Product Change Notification - SYST-16FCTK442

ERRATA - dsPIC33FJ32GS406/606/608/610 and dsPIC33FJ64GS406/606/608/610 Sil Err and DS Cla

dsPIC33FJ32GS406/606/608/610 and dsPIC33FJ64GS406/606/608/610 Family Silicon Errata and Data Sheet Clarification

FIGURE 1: TIMING DIAGRAMS FOR CENTER-ALIGNED AND EDGE-ALIGNED MODES

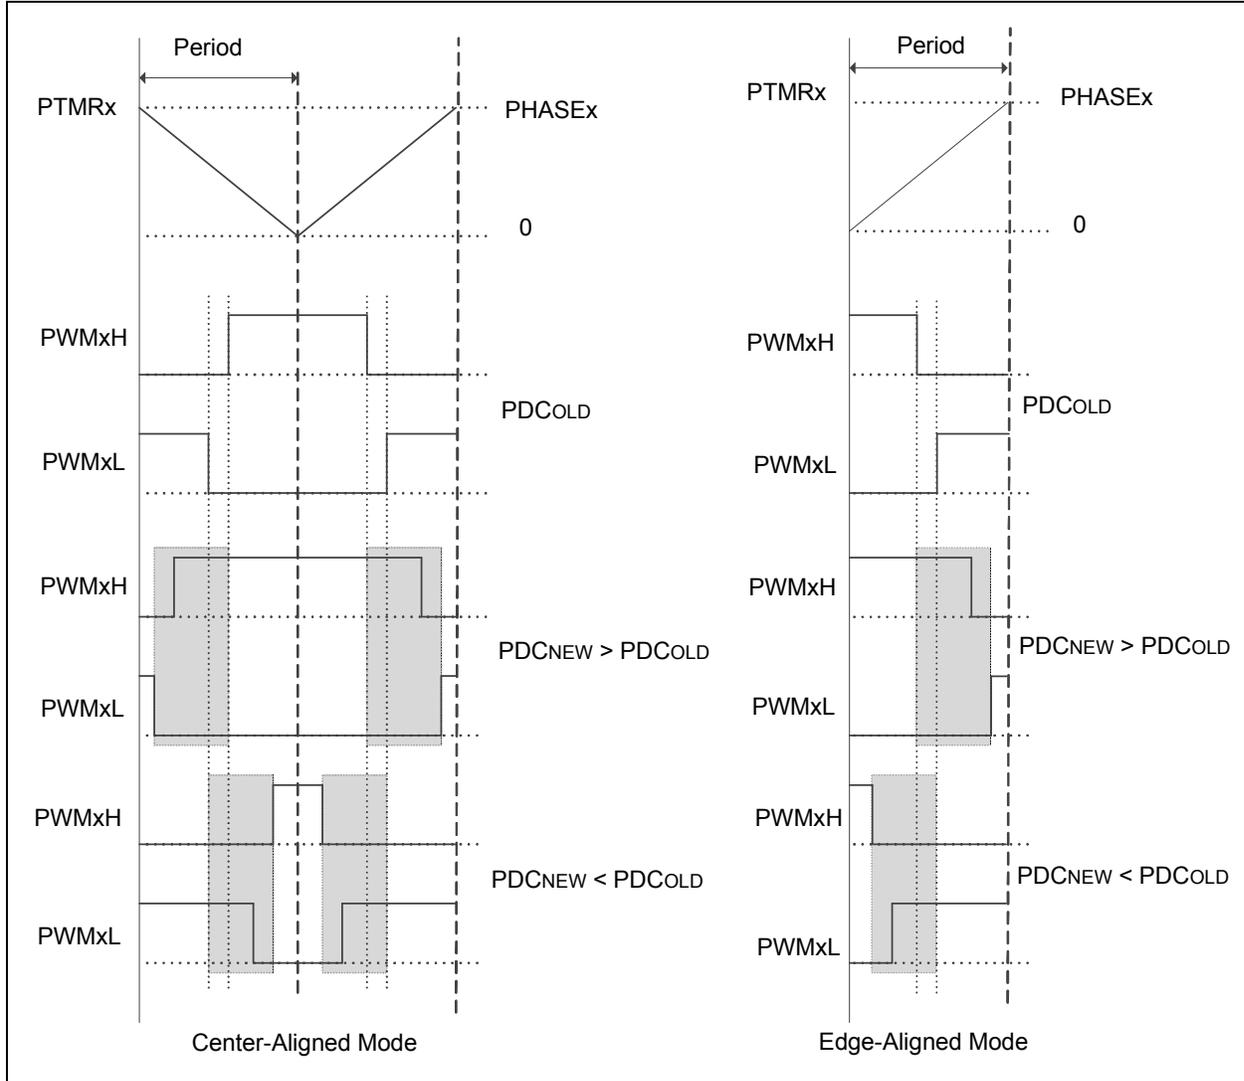
The PWMx generator may not assert dead time on the edges of transitions. This has been observed when all of the following conditions are present:

- The PWMx generator is configured to operate in Complementary mode with the independent time base or master time base;
- Immediate update is enabled; and
- The value in the PDCx register is updated in such a manner that the PWMxH and PWMxL outputs make an immediate transition.

The current duty cycle, PDCOLD, newly calculated duty cycle, PDCNEW, and the point at which the write to the Duty Cycle register occurs within the PWMx time base, will determine if the PWMxH and PWMxL outputs make an immediate transition. PWMxH and PWMxL outputs make an immediate transition if the Duty Cycle register is written with a new value, PDCNEW, at a point of time when the PWMx time base is counting a value that is in between PDCNEW and PDCOLD. Additionally, writing to the Duty Cycle register close to the instant of time where dead time is being applied may result in reduced dead time, effective on the PWMxH and PWMxL transition edges.

In [Figure 1](#) (following page), if the duty cycle write occurred in the shaded box, then PWMxH and PWMxL will make an immediate transition without dead time.

None. However, in most applications the duty cycle update timing can be controlled using the TRIGx trigger or Special Event Trigger, such that the above mentioned conditions are avoided altogether.

FIGURE 2: ISSUE EXAMPLE FOR REDUNDANT OUTPUT MODE

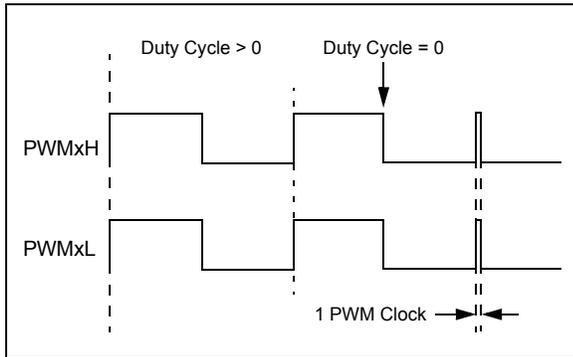
In Redundant Output mode (IOCONx[11:10] = 01) and Push-Pull Output mode (IOCONx[11:10] = 10), with the Immediate Update Enable bit disabled (PWMCONx[0] = 0), when the Duty Cycle register is updated from a non-zero value to zero, a glitch pulse of a width equal to one PWM clock will appear at the next PWM period boundary, as shown in Figure 2 (for the Redundant Output mode). The Duty Cycle register refers to the PDCx register if PWMCONx[8] = 0 or the MDC register if PWMCONx[8] = 1.

If the application requires a zero duty cycle output, there are two possible work around methods:

1. Use the PWM override feature to override the PWM output to a low state instead of writing to the Duty Cycle register. In order to switch back to a non-zero duty cycle output, turn off the PWM override. The override-on and override-off events must be timed close to the PWM period boundary if the IOCONx register has been configured with IOCONx[0] = 0 (i.e., output overrides through the OVDDAT[1:0] bits occur on the next CPU clock boundary).
2. Enable the Immediate Update Enable bit (PWMCONx[0] = 1) while configuring the PWMx module (i.e., before enabling the PWMx module, PTCON[15] = 1). With the Immediate Update enabled, writes to the Duty Cycle register can have an immediate effect on the PWM output. Therefore, the duty cycle write operations must be timed close to the PWM period boundary in order to avoid distortions in the PWM output.

FIGURE 3:

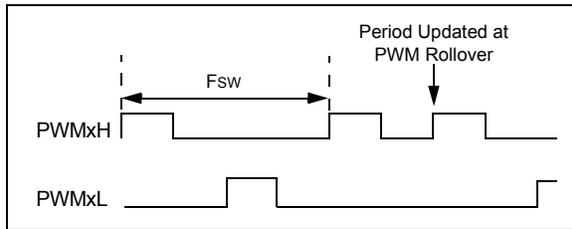
When the PWM module is configured for Push-Pull mode (IOCONx[11:10] = 10) with the Enable Immediate Period Update bit enabled (PTCON [10] = 1), a write to the Period register that coincides with the period rollover event may cause the push-pull output logic to produce back-to-back pulses on the PWMx pins (Figure 3).

Ensure that the update to the PWM Period register occurs away from the PWM rollover event by setting the EIPU bit (PTCON[10] = 1). Use either the PWM Special Event Trigger (SEVTCMP) or the PWM Primary Trigger (TRIGx) to generate a PWM Interrupt Service Routine (ISR) near the start of the PWM cycle. This ISR will ensure that period writes do not occur near the PWM period rollover event.

FIGURE 4: ENCODER IN THE SECTOR AROUND THE INDEX MARK

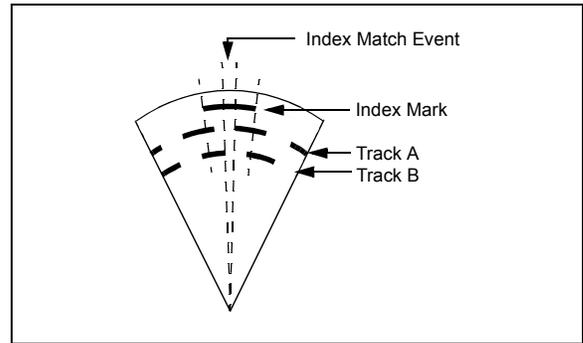
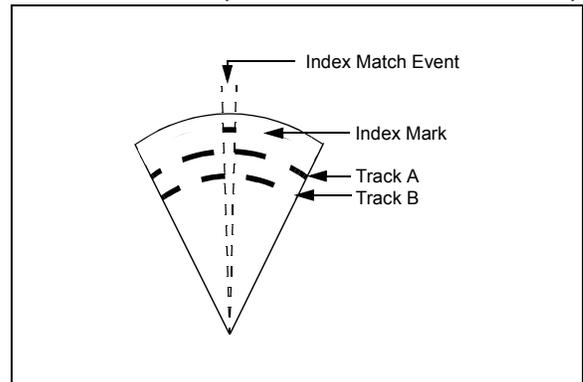
When the QEI module is used in 4x mode with Index Pulse Reset (QEIM[2:0] = 110), the value of the POSxCNT register may not transition (rollover or underflow) from zero to the maximum count value as expected.

This issue is most likely to be seen in specific motor applications using a rotation encoder with an ungated index pulse, operating at near zero speed and/or in the presence of mechanical vibration. In these applications, the encoder may change direction and incrementally rock back and forth. If this happens with the encoder positioned in the vicinity of its index mark, the module will detect the first index match event as the encoder rotates into the index match event area, but not subsequent events if it drifts into and out of that position but stays within the index mark area (Figure 4). If the encoder count increments or decrements in only one direction, the index match will only occur once.

As a result of this, the value of POSxCNT may leave its expected range of 0 to maximum count (defined as the number of encoder pulses per revolution, minus 1), resulting in erroneous reporting of the rotor's position.

This issue is not seen when the encoder uses an index mark that is one encoder count in width (Figure 5).

None.
